**AMERICAN ELECTRIC POWER SERVICE CORPORATION
MECHANICAL ENGINEERING DIVISION
HEAT EXCHANGERS & PUMPS SECTION**

SUBJECT: Verification of The NOV 21, 1979
Auxiliary Feed pump's Net Positive
suction head Available.

E/C IDENTIFICATION NO: HXP791121AF REVISION NO. 1

HXP791121AF - Verification of the Nov 21, 1979 Auxiliary Feed Pumps Net Positive
Suction Head Available

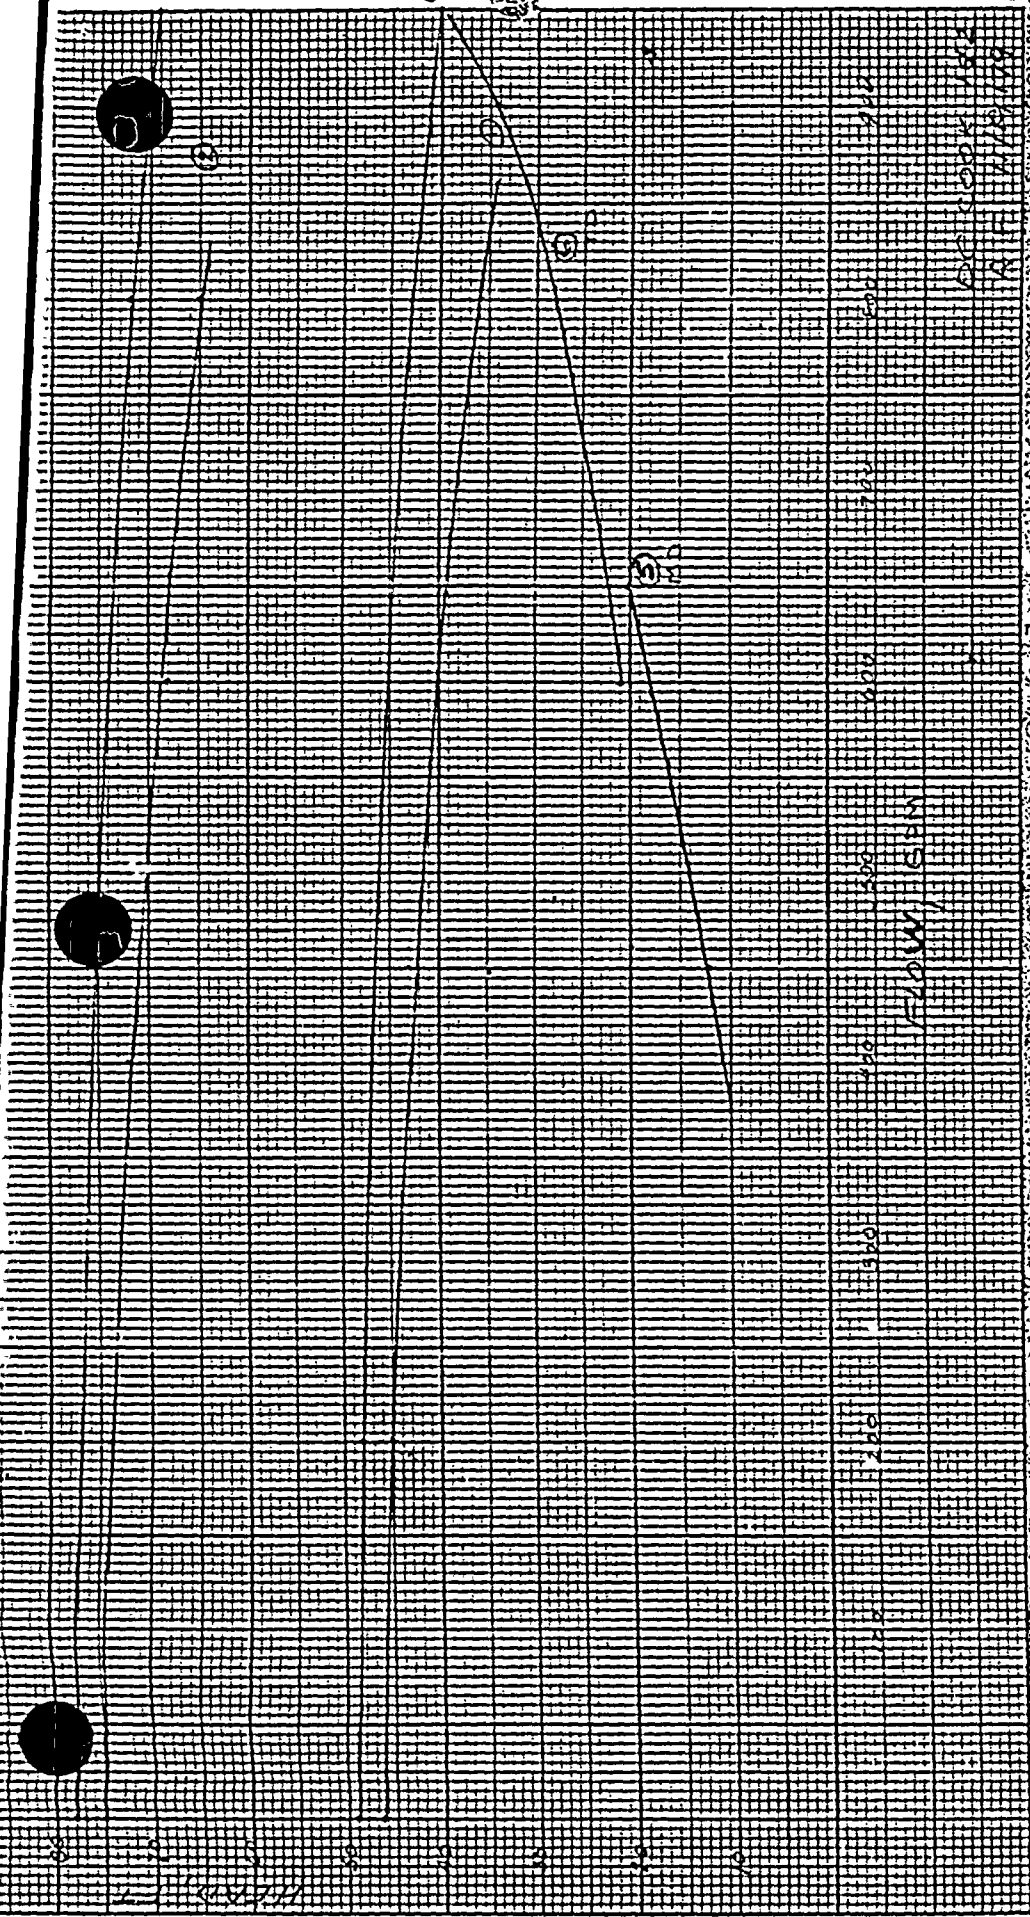
Page 6 of 6 of the attachment is not completely legible.
